EXHIBIT N

Public Comment

Notice of Application - Noll Pointe PRD - File No. P-09-10-25-01

Re: File No. P-09-10-25-01 – Noll Pointe Planned Residential Development (PRD)

Ref. (2) – Noll Pointe – Preliminary Plat Plan – Page C1.00 (annotated) – (attached)

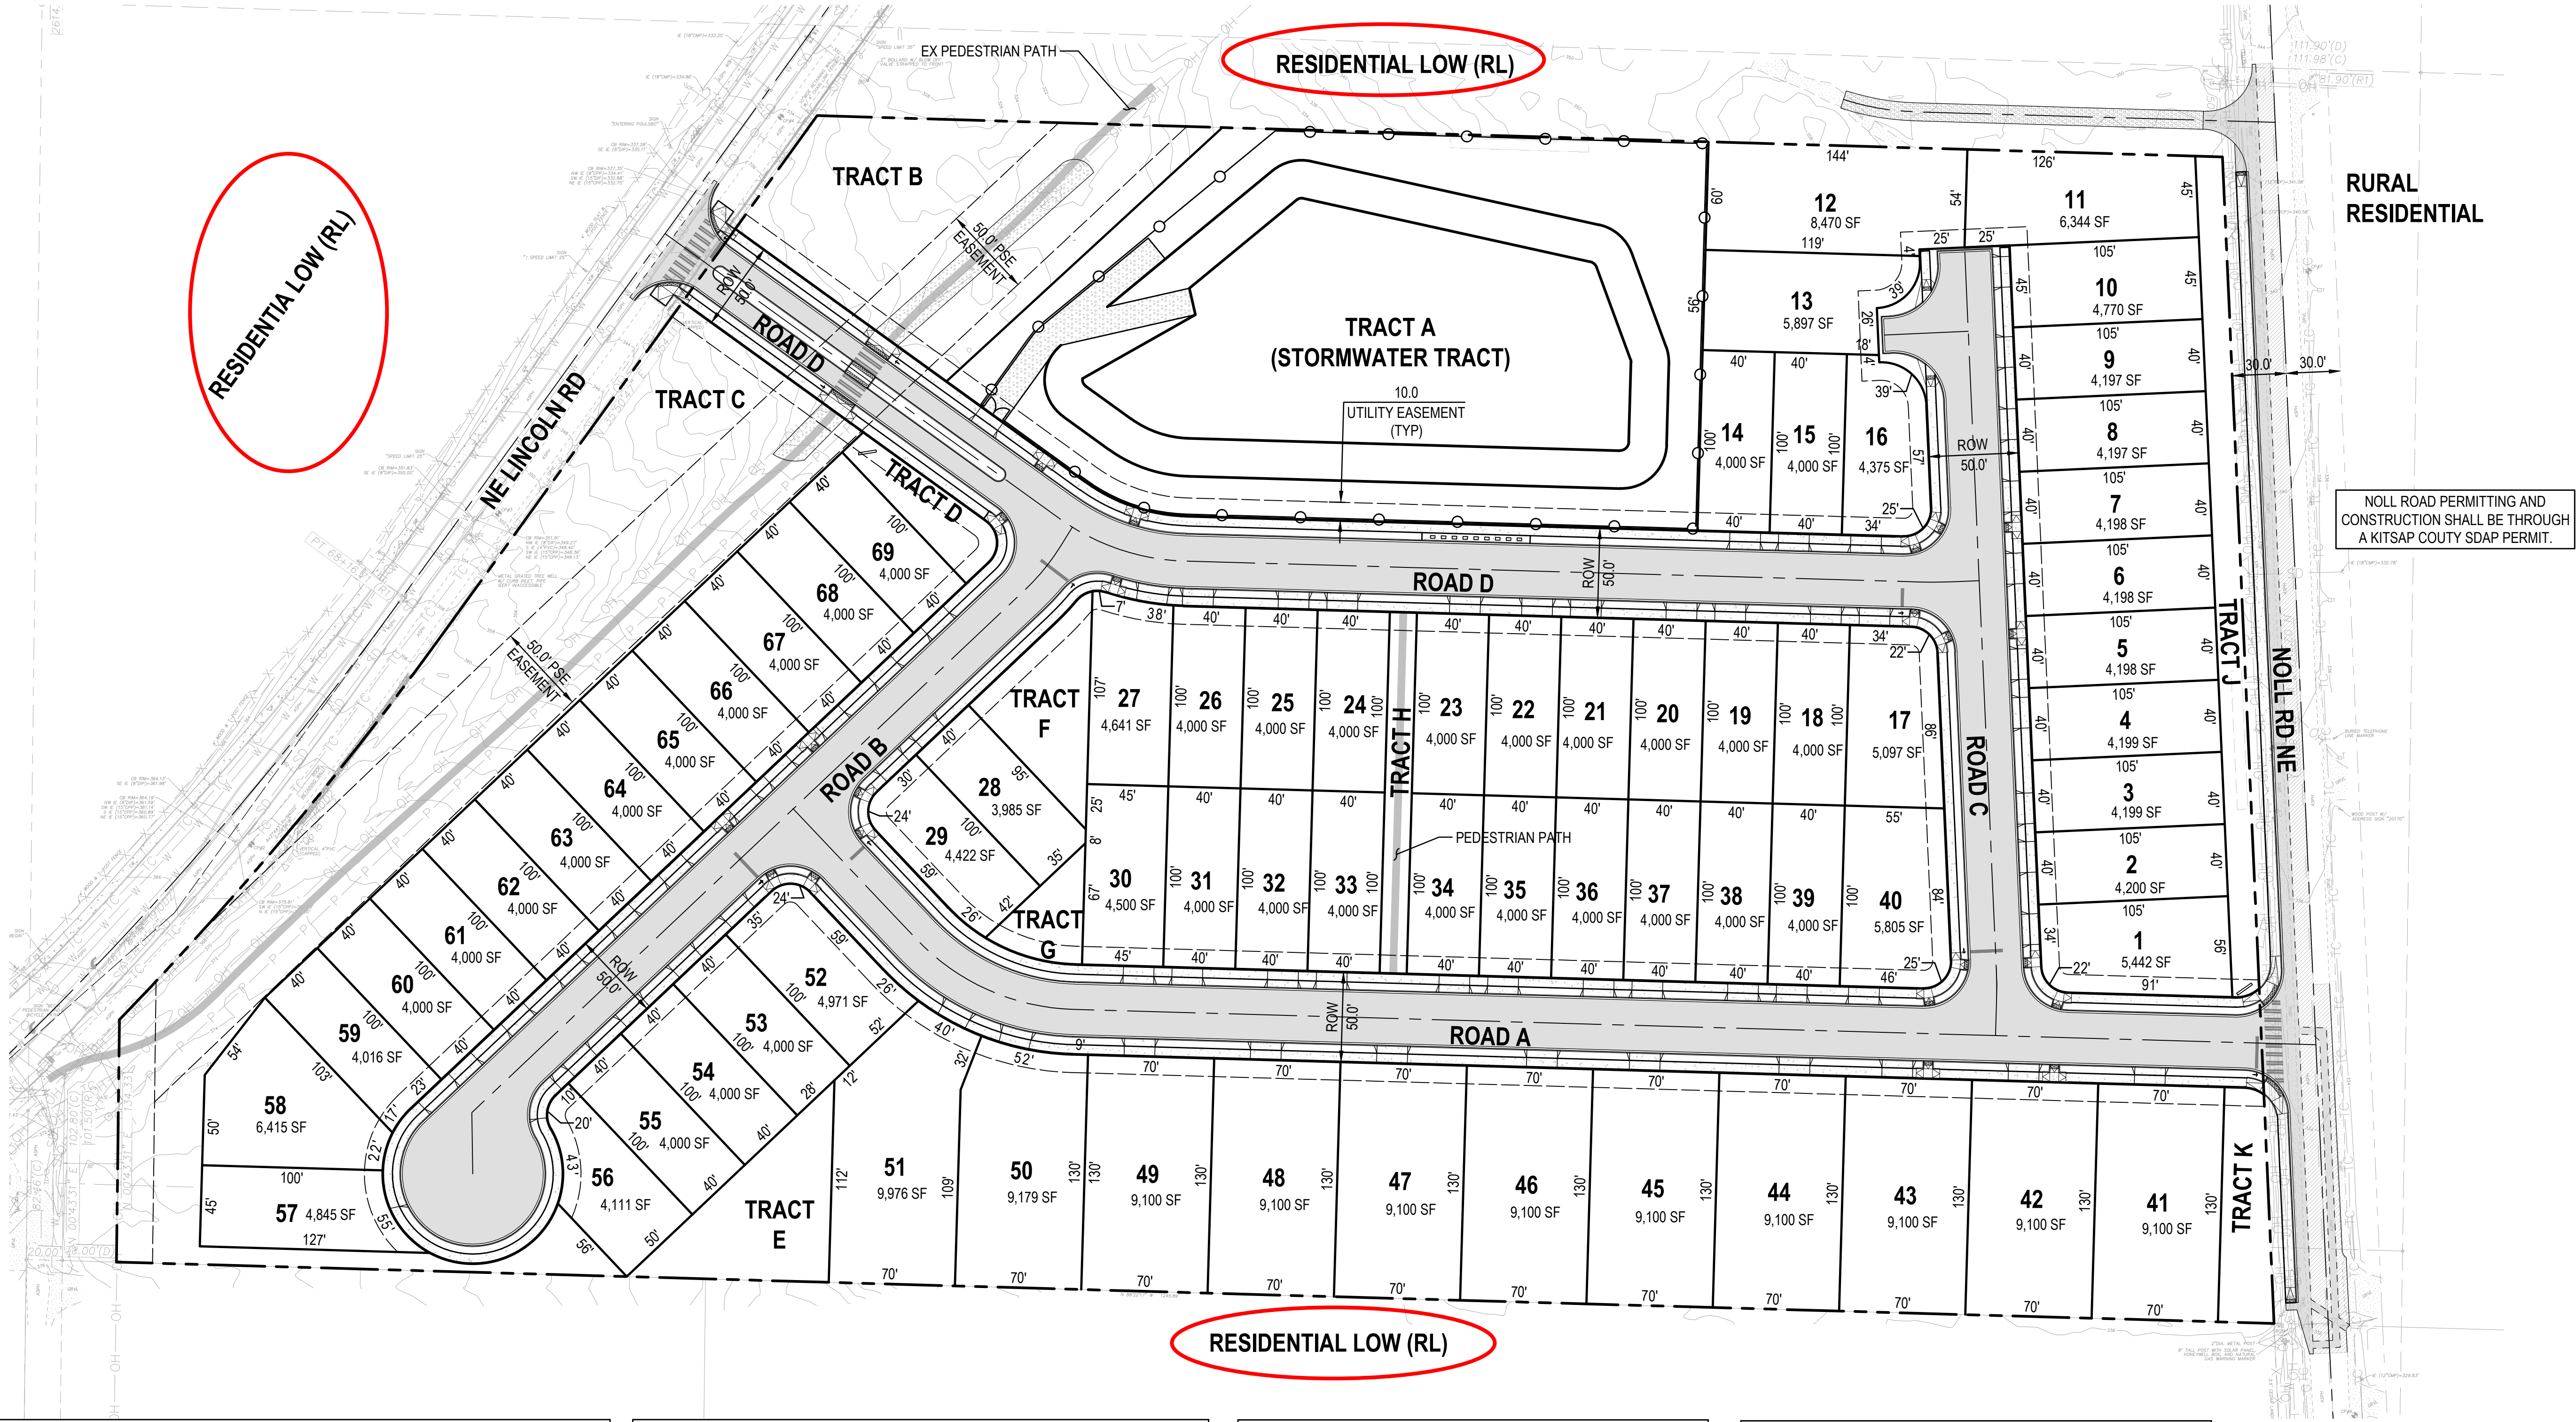
The most appropriate way for the proposed Noll Point PRD to be compliant with subsection B of Section 18.26.070 of the PMC would be for the referenced Preliminary Plat Plan to be redesigned so that the entire perimeter of the PRD includes screening in the form of a “minimum twenty-five-foot vegetated buffer”. The required vegetation should preferably reflect retention of as many native trees as possible, consistent with the emphasis on the preservation of trees whenever and wherever possible, in line with the provisions of Chapter 18.180 of the PMC. The review authority does have the discretion to require the applicant to provide a six-foot sight-obscuring fence, as an alternative means of providing the mandatory screening. However, that discretion is guided by the requirement that the PRD comply with subsection B in a manner “deemed appropriate to provide **adequate** screening” (emphasis added). Given that the applicant proposes that the homes in the PRD will be two-story, a six-foot fence is wholly inadequate to provide effective screening. A twenty-five-foot vegetated (with native trees and additional trees planted) buffer is clearly more appropriate.

The redesign of the referenced Preliminary Plat Plan to provide vegetated buffer screening would affect the currently labeled lots 11 and 12 to the north, lots 58 through 69 to the west, lots 41 through 51 plus lots 56 and 57 to the south and lots 1 through 10 to the east. The referenced Preliminary Plat Plan and the applicant’s submitted Open Space Plan (Ref. (3)) identifies each of Tract B and Tract C on the west side of the proposed PRD as being, respectively, a “PRD Recreation Tract” or a “Tree Retention, Open Space, Recreation” tract. It is notable that PSE power lines run overhead through both Tracts B and C, thus mandating the

application of any PSE rules on the presence of plantings beneath the power lines. Perhaps a portion of Tracts B and C might retain native trees or add newly planted trees. If some parts of those tracts would be dedicated to recreation, that would imply those areas would be grass lawn rather than containing trees. To the extent that any trees preserved or added in Tracts B and C fail to satisfy the screening obligations of subsection B of Section 18.260.070 of the PMC, the redesign of the PRD should be required to address any gaps.

- a. The City code for Planned residential Developments Section 18.260.070 provides options. Per Section 18.260.070(A), the project has matched the square footage and widths of the lots adjacent to the Noll Valley Loop plat.

- b. Per Section 18.260.070(B), there is an option to either provide a 25 foot vegetated buffer or a six-foot site obscuring fence. The applicant has chosen to utilize the 6 foot site obscuring fence. The applicant has concerns not only for the residences that will reside in the proposed project but those that abut the southern boundary of the project. It is our experience that a 25 foot vegetative buffer with existing trees can be susceptible to wind throw as the remaining trees will now be exposed to winds they have not previously been exposed to. With that, they can very easily be blown over on to fences and residences. We value the safety of our customers and neighbors and have chosen the fencing option as allowed by code.

Attachment 2. Sandstone Ridge Site Plan

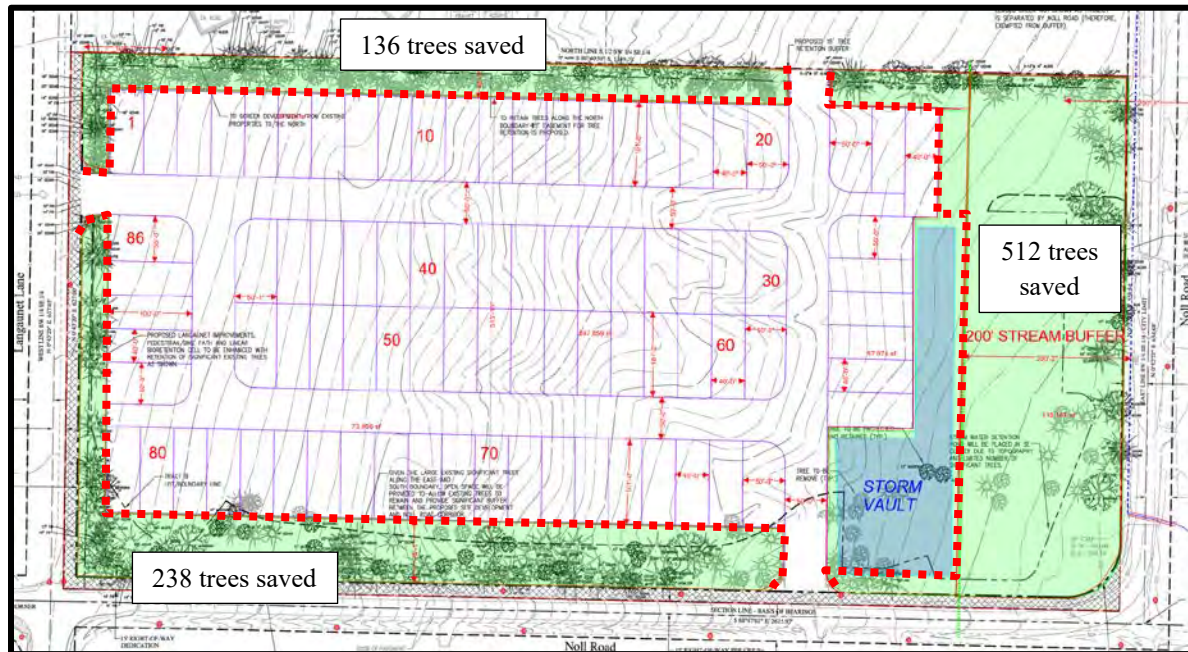
The Sandstone Ridge housing development recently approved by the review authority offers an exemplary approach by a PRD to honor both the letter and spirit of subsection B of Section 18.260.070 of the PMC (see attached Ref. (4) page from the Tree Protection Plan submitted as part of the Sandstone Ridge PRD application). The tree retention spaces in the Sandstone Ridge plan completely surround the subdivision (except for street openings). The Sandstone Ridge applicant has incorporated a community amenity of a walking trail that runs through the tree retention areas and thus encircles the neighborhood. The Sandstone Ridge PRD is only a half mile south of the proposed Noll Pointe PRD, which makes comparison of the two most apt. The Noll Pointe applicant might want to consider the Sandstone Ridge example when redesigning the Noll Pointe layout.

LANDSCAPE PLAN

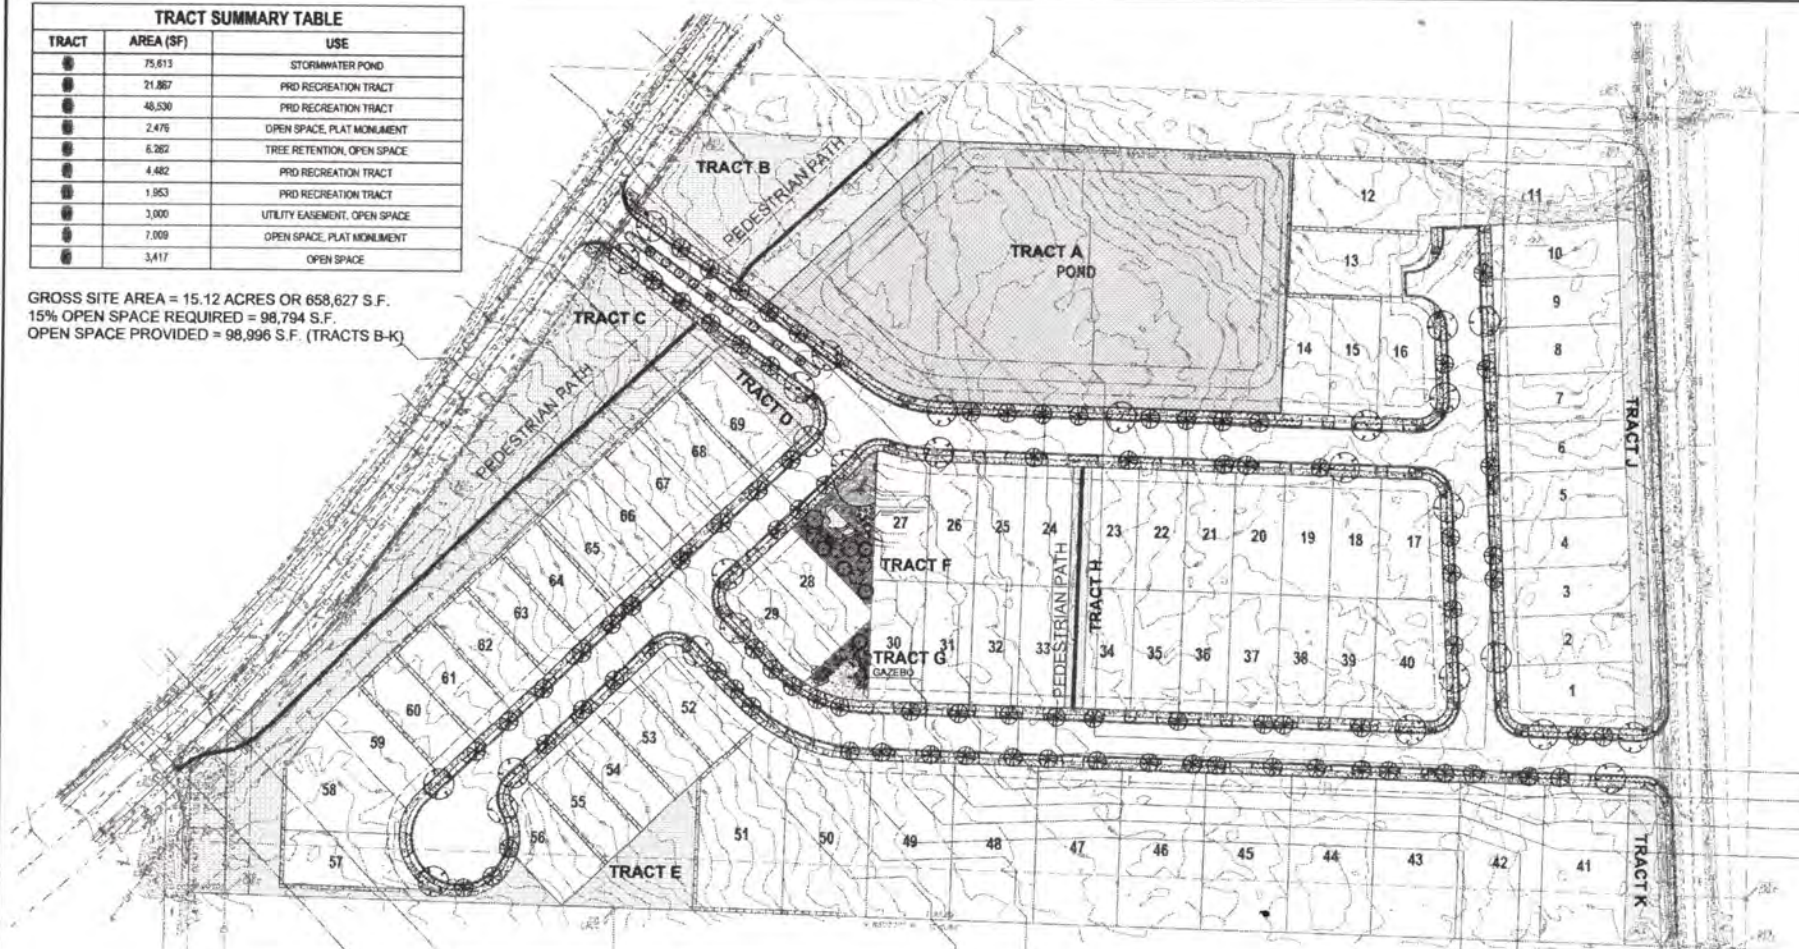
Turning your attention to the Noll Pointe Landscape Plan attachment, why is there a landscape buffer planned for the perimeter of the development and all internal streets and sidewalks but nothing between the two subdivisions? Given the planned placement of a 50’ to 60’ setback of the homes from the rear lot line on the 11 lots in question, certainly 5’ to 8’ of a treescape buffer is not out of the ordinary in the course of residential development.

4. Concerns over the perimeter landscape buffer planned for the project, in relation to the common boundary line between the project and the abu4 ng homes of the Noll Valley Loop single-family development.

Fig 1. WFC map

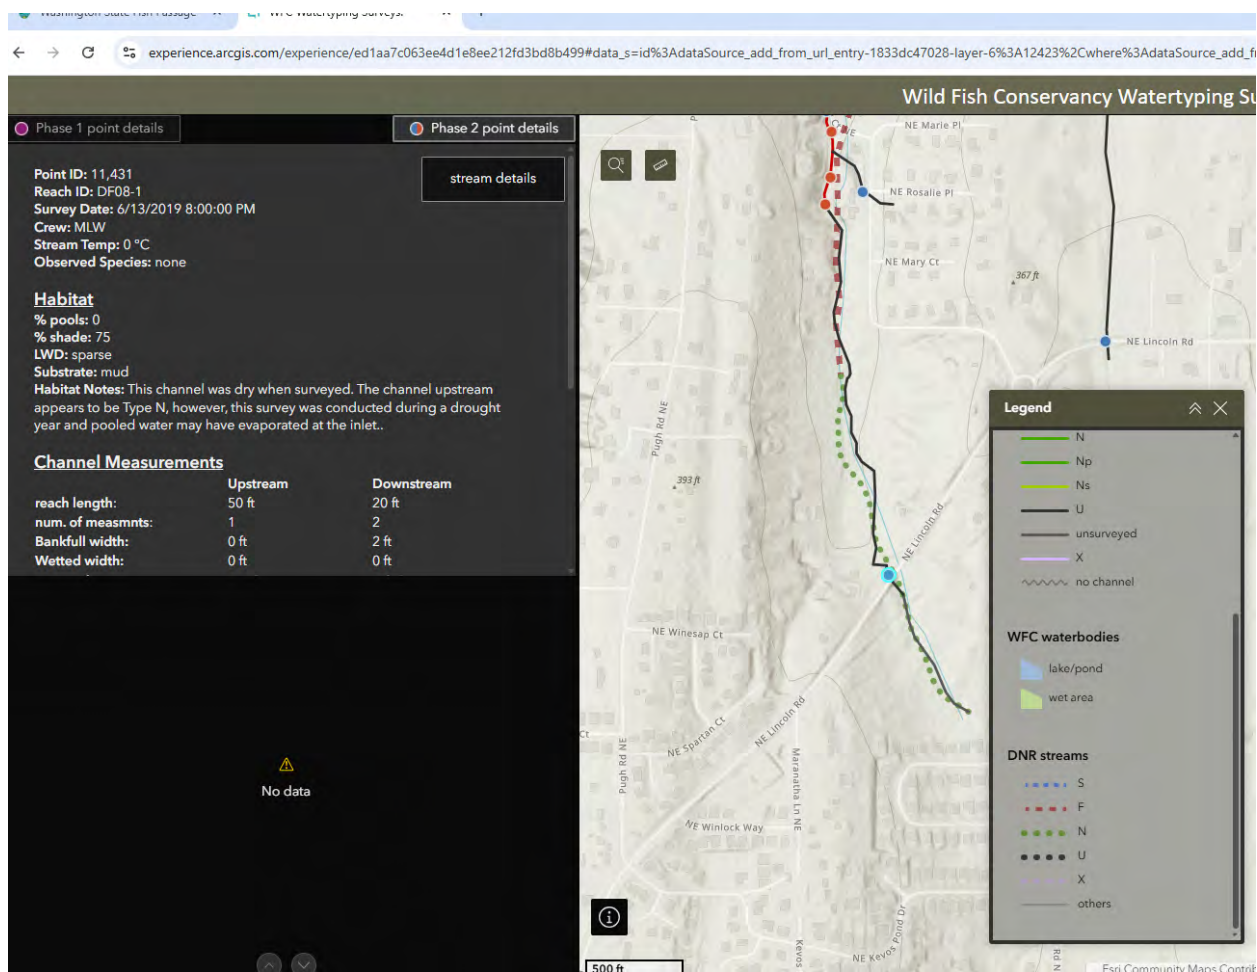
The Wild Fish Conservancy apparently surveyed the stream in 2019 and shows deviations from the mapped location as well as the stream extending into the property (Fig 1). The narrative part of their map includes the following:

This is a 1.6ft. ABS pipe crossing NE Lincoln Rd. The channel upstream is not well defined. The channel downstream may be Type F (need more data). There is a 0.33ft. overflow pipe at the site also. Road fill is 8.0ft.

The survey was conducted in the road right-of-way during a lower than normal flow year. The channel downstream meets Type F physicals, however, more data is needed. The riparian corridor downstream is composed of big-leaf maple, salmonberry, and nettle.”

Additionally, the “Wetland and Stream Determination” report gives emphasis to a lack of defined channel. In 2026, there have been updates to water typing. Though in the past, off-channel habitats of Type F streams could be categorized as Type F, field assessments often fixated upon a need for a defined channel. Updates to the WACs have expanded the definition to include nonchannelized streams. Also, areas of undefined channel that are fish passable are often used by juvenile fish to move between areas of defined channel.

SITE MAP
JKM HOLDINGS - NOLL ROAD NE

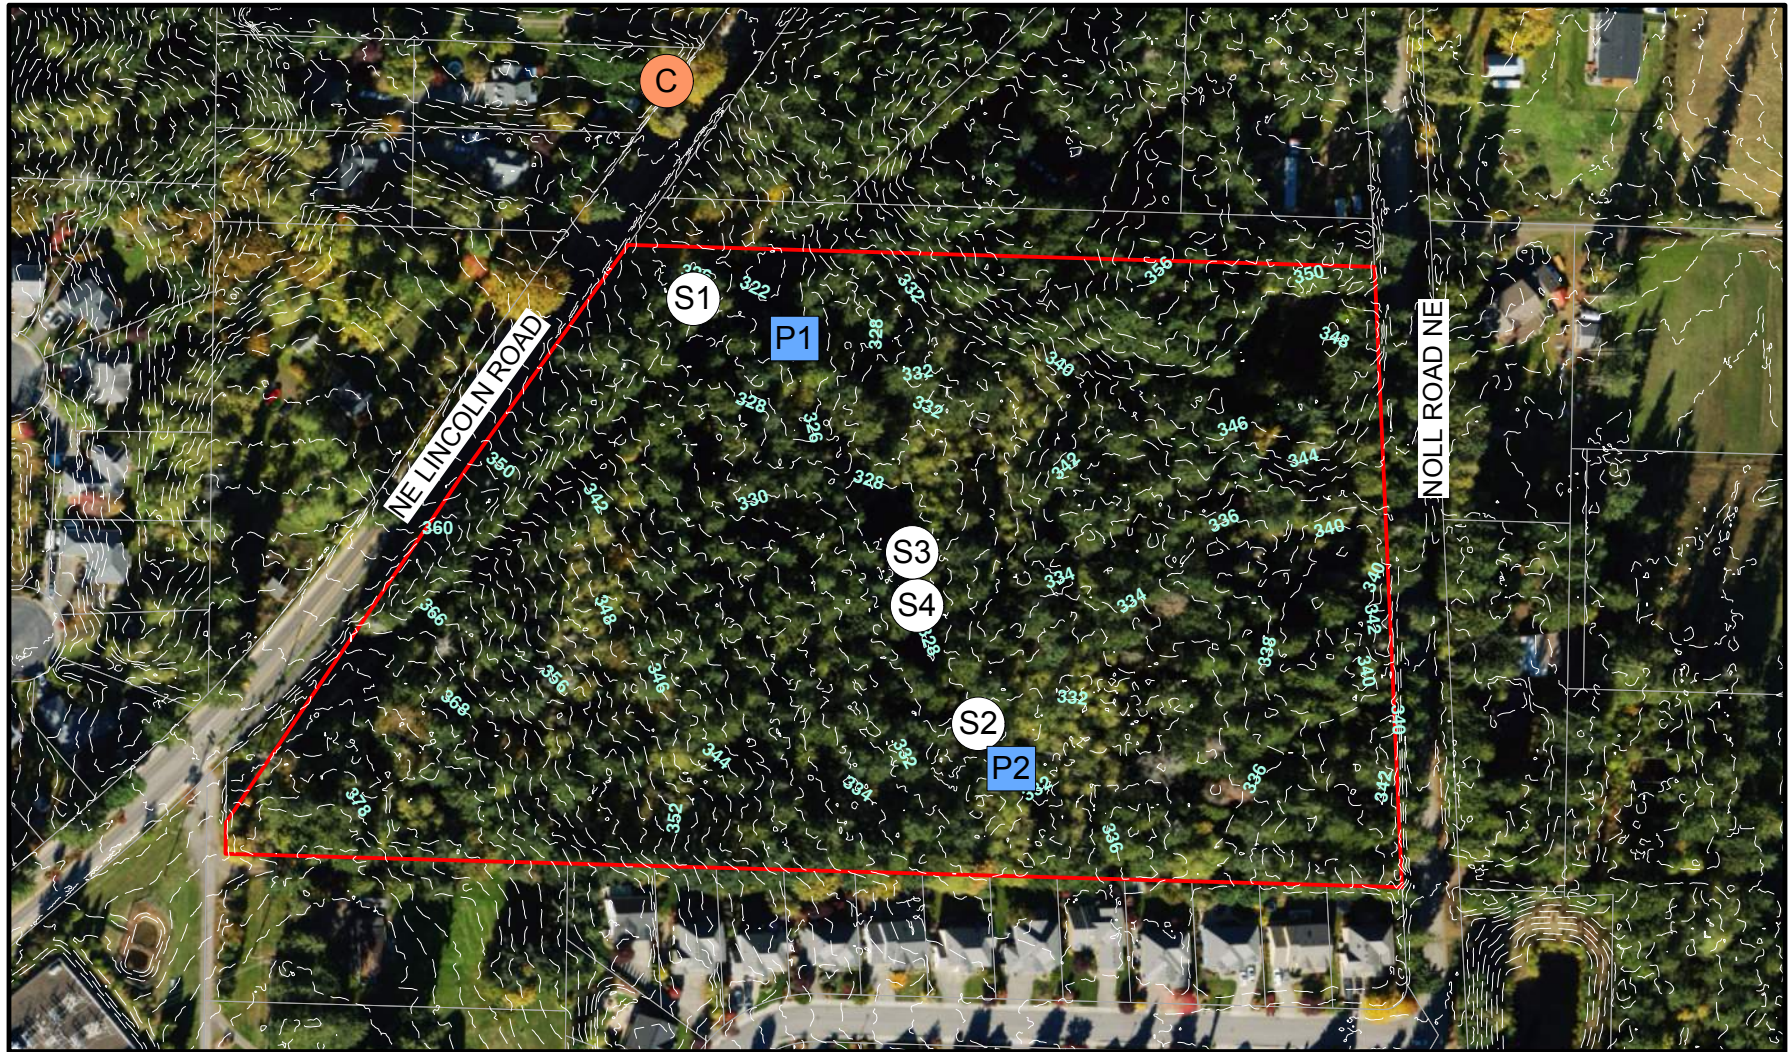
The locations of streams are often incorrectly mapped and, at times, there can be more stream crossings of a road than shown on a map. A field visit that looks for evidence of a stream in the location shown on a map, can overlook the presence of a stream or a road crossing in another location. It should be clarified if the site visits mentioned in the report traversed the property looking for evidence of a stream or only looked at the location shown on maps. It should be clarified if during the site visit if only the location of the mapped stream/culvert was looked at.

Photographs were taken during the March 2025 site visit at the lowest points on the site to show existing conditions in the area most likely to exhibit stream or wetland conditions. These photos were included in the report, and copies are enclosed with this letter. A map showing the photo points, data points, and two-foot contours is also enclosed with this response. Photo Point One

shows the lowest area of the site and it contains a dense upland plant community. Photo Point Two is within the lower elevations of the property and shows a layer of intact leaf litter. If the site contained flowing or ponded water, even periodically, an even layer of leaves on the ground and dense upland plants would not be present.
